Access Compliance Report

Public Rights-of-Way

Intersection ID: 47103	Main Street: POLK_AND_WHITE_RD	Cross Street: HATTIE_LITTLE_ST	Location: NE
ADA ID: D1FAC177516F	Ramp Type: BlendTrans1	Initial Pass/Fail: Fail	Overall Compliance: No
		Severity Score: 10

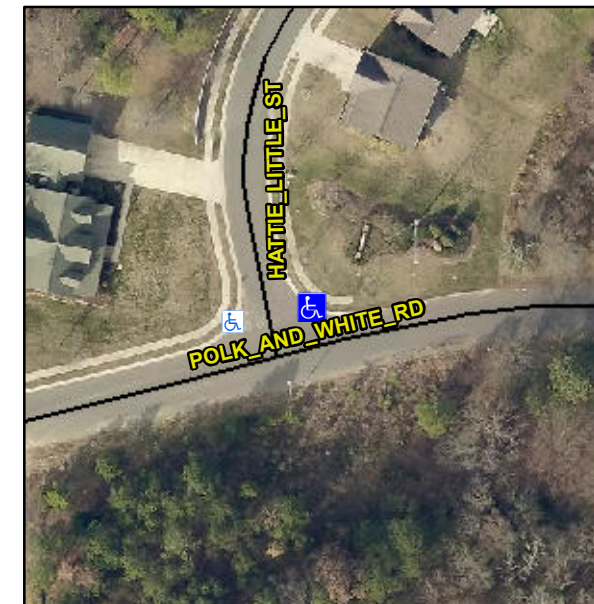
Not Found, R304.5.1, R304.5.3

Compliance	Description	Data	Compliance	Description	Data
N/A	Ramp Length (in)	49.0	Yes	BlendTrans Slope (%)	3.3
No	Ramp Width (in)	42.0	No	BlendTrans XSlope (%)	3.8
N/A	Flare Type LT	N/A	N/A	Flare Type RT	N/A
N/A	Flare Slope LT (%)	N/A	N/A	Flare Slope RT (%)	N/A
N/A	Flare Traversable LT?	N/A	N/A	Flare Traversable RT?	N/A
N/A	Landing Length (in)	N/A	N/A	DWS Provided?	N/A
N/A	Landing Width (in)	N/A	N/A	DWS Contrast?	N/A
N/A	Landing Slope (%)	N/A	N/A	DWS Length (in)	N/A
N/A	Landing X Slope (%)	N/A	N/A	DWS Full Width?	N/A
N/A	Landing Curb? (Y/N)	N/A	N/A	DWS Offset (in)	N/A
N/A	Shared Landing?	N/A			
N/A	Gutter Ponding?	N/A	N/A	Gutter Slope (%)	N/A
N/A	Gutter Lip Ht (in)	N/A	N/A	Gutter X Slope (%)	N/A
N/A	Painted X Walk1?	No	N/A	Painted X Walk2?	N/A
	X Walk 1 Direction	To SW		X Walk 2 Direction	N/A
	X Walk 1 Width (in)	N/A		X Walk 2 Width (in)	N/A
	X Walk 1 Slope (%)	1.9		X Walk 2 Slope (%)	N/A
	X Walk 1 X Slope (%)	0.2		X Walk 2 X Slope (%)	N/A

N/A	Ramp inside XWalk1?	N/A	N/A	Ramp inside XWalk2?	N/A
	Road Slope (%)	0.2		Clear Space?	N/A
	Road X Slope (%)	1.9	N/A	Clear Space to XWalk (in)	N/A
N/A	Any Obstructions?	N/A	N/A	Storm Grate/Utility Hazard?	N/A
	Obstruction Type			Storm Grate/Utility Type	
		N/A			N/A
			Yes	Surface Condition? (G/P)	Good
			No	Curb Slope (%)	7.3

Remove & Replace Curb Ramp With Two New Directional Ramps or Equivalent.
